SERVICE BULLETIN NO. OSB817-066

ATA-Code: 34-40 Independent Position Determining
Provisions to install PowerFLARM

These information or instructions relate to change no. OÄM817-039 which has been approved under the authority of EASA Design Organisation Approval No. EASA.21J.030.

Figure 2 Switch Panel with new drilled hole and placard "FLARM ON OFF"

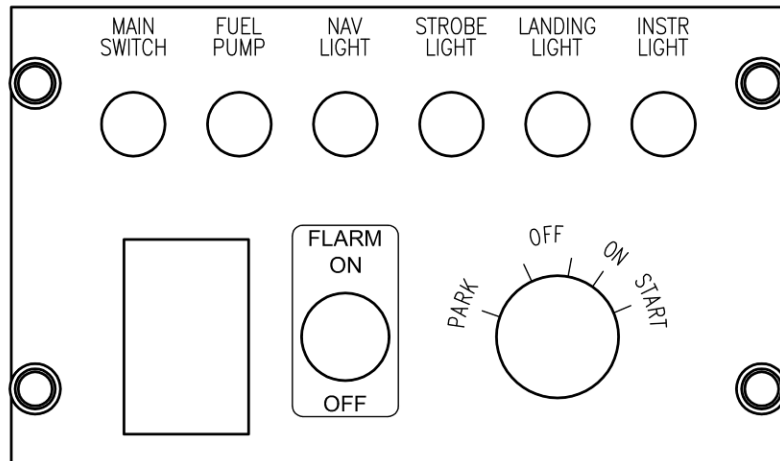
- 1.8.7 Record all switch positions and cable connections. Remove and keep all switches and the insulation angle 109B-7000.32 (between the top row of the toggle switches and the transponder unit) from the switch panel.
- 1.8.8 Apply the drilling template (Item 1 of List 2.3) onto the switch panel. Drill a hole with a 4mm drill.
- 1.8.9 Remove the template. Drill the new hole with a 12 mm drill in the switch panel.
- 1.8.10 Apply placard "FLARM ON OFF" (Item 1 of List 2.2) to the front side at the switch position. Install the new FLARM switch (Item 2 of List 2.2).

- 1.8.11 Install all toggle switches together with insulation angle 109B-7000.32. Install the ignition switch and mute switch into the switch plate, refer to Figure 2.
- 1.8.12 Install the new 2A "FLARM" Circuit Breaker (CB) (item 3 of List 2.2) to the CB-Panel at the third position from the left side in the front row. Remove and discard original installed plastic cap.
- 1.8.13 Connect the new circuit breaker to the main bus with the jumper cable 109B-9530 (Item 4 of List 2.2). Attach it to the existing cable loom with a cable tie, refer to Figure 3 and Figure 5 (orange line).

Figure 5 Cable Routing inside instrument compartment

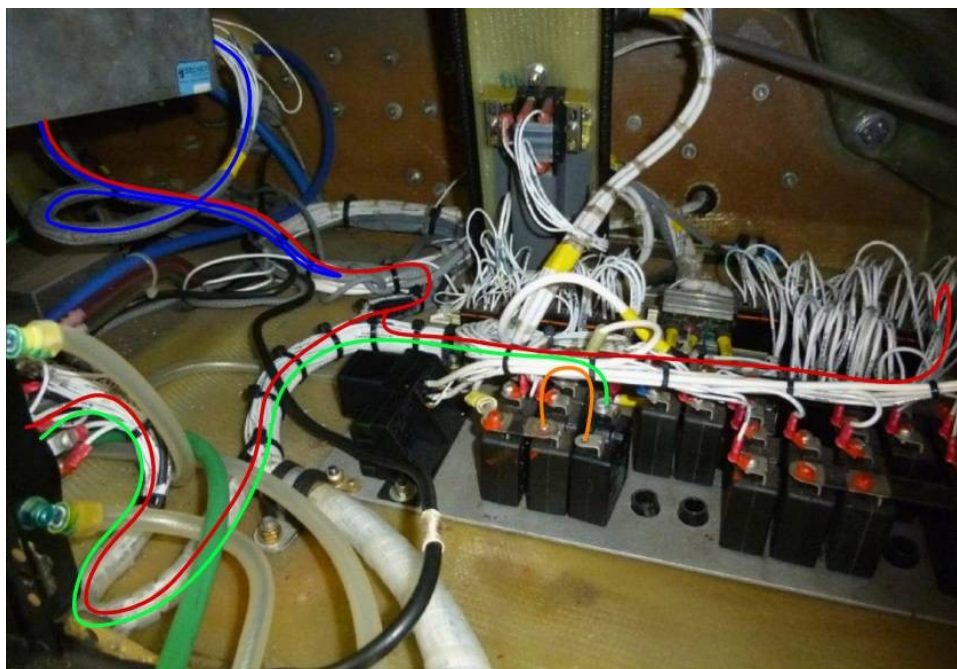
- 1.8.16 Connect the wire WN 01E22-P (cable loom FLARM 2, 109B-9520, item 6 of List 2.2) to the other connector of FLARM CB and put it along the original loom to the FLARM switch (2WN) at the switch plate, refer to Figure 5 (green line). Safety the screw at the CB with inspection lacquer.

- 1.8.25 Put the wires WN 02E22N-P and WN 03E22N-P of cable loom FLARM 1 along the original cables to ground module VV1, Terminal 5. Cut them to length and strip the insulation of the wires (Figure 5 – right red line).

- 1.8.28 Put the wire WN 04E22-S of cable loom FLARM 1 inside the grey braided sleeving to the BECKER AR3201 transceiver (Figure 5 – blue line).
- 1.8.29 Disconnect connector 2RV-a from the BECKER AR3201 transceiver. Remove the backshell and the associated parts and unsolder wire RV 2F20N from pin 2 of the connector 2RV-a.

Figure 6 Connection at back side of 2WN switch

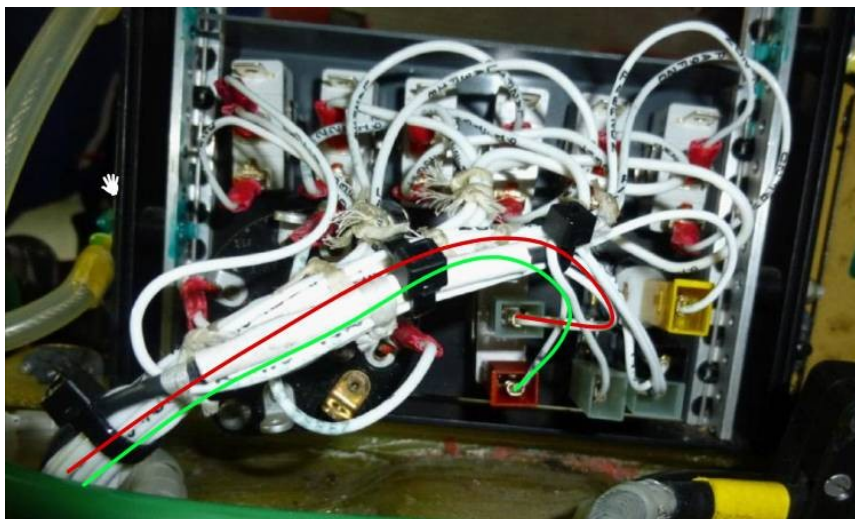
- 1.8.17 Cut the wire WN 01E22-P to correct length and strip the insulation of the wire. Crimp the contact AMP 160773-6 (positive lock receptacle, item 7 of List 2.2) onto the wire. Use the hand crimping tool AMP 354940-1 with Die Set AMP 90575-2 or equivalent. Install an insulator AMP 154719-2 (positive lock receptacle insulator, red, item 8 of List 2.2) to the crimped contact. Connect cable to the bottom connector of the FLARM switch (2WN) (refer to Figure 6 – green line).

- 1.8.24 Crimp the two wires together into one contact AMP 160773-6 (positive lock receptacle, Item 7 of List 2.2). Use the hand crimping tool AMP 354940-1 with Die Set AMP 90575-2 or equivalent. Install an insulator AMP 154719-1 (positive lock receptacle insulator, natural, Item 15 of List 2.2) to the crimped contact. Connect the cable to the top connector of the FLARM switch (2WN) (refer to Figure 5 and Figure 6 – red lines).

Figure 8 Installation of Resistor between Pin 1 and 2 of Plug 2RV-a.

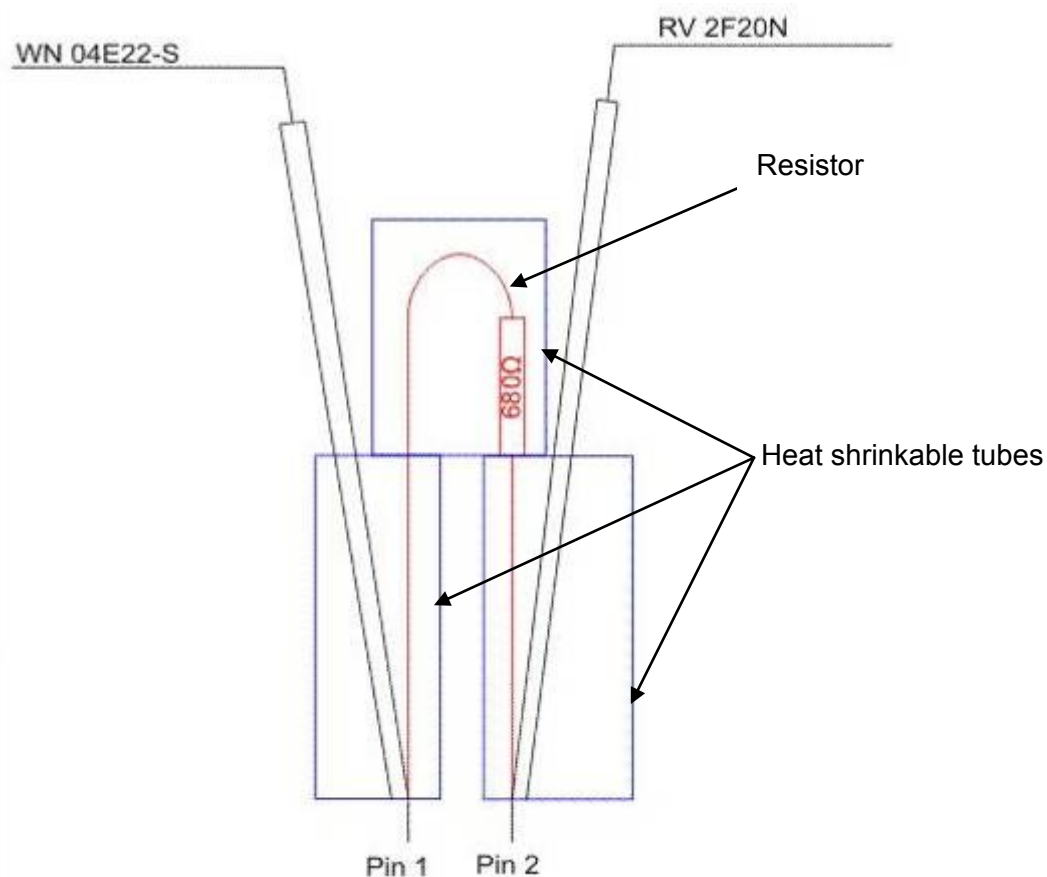
- 1.8.30 Bend one lead of the 680 Ohm resistor (Item 17 of List 2.2) by 180° and cut straight lead to the same length. Cut two heat shrinkable tubes (Item 18 of List 2.2) to the length of the leads, refer to Figure 8.

- 1.8.31 Cut the wire WN 04E22-S of cable loom FLARM 1 to length and strip the insulation of the wire. Put this wire with one lead of the prepared resistor through one heat shrinkable tube. Solder wire and resistor to pin 1 of connector 2RV-a (Figure 8, left side).

- 1.8.32 Put RV 2F20N with the other lead of the resistor through one heat shrinkable tube. Solder wire and resistor to pin 2 of connector 2RV-a (see Figure 8, right side).

- 1.8.33 Shrink the two heat shrinkable tubes over the pins, wire and lead with a heating gun.
- 1.8.34 Put the third heat shrinkable tube over the remaining parts of the resistor as protection (refer to Figure 8). Shrink it with a heating gun. Cut remaining tube, if necessary.
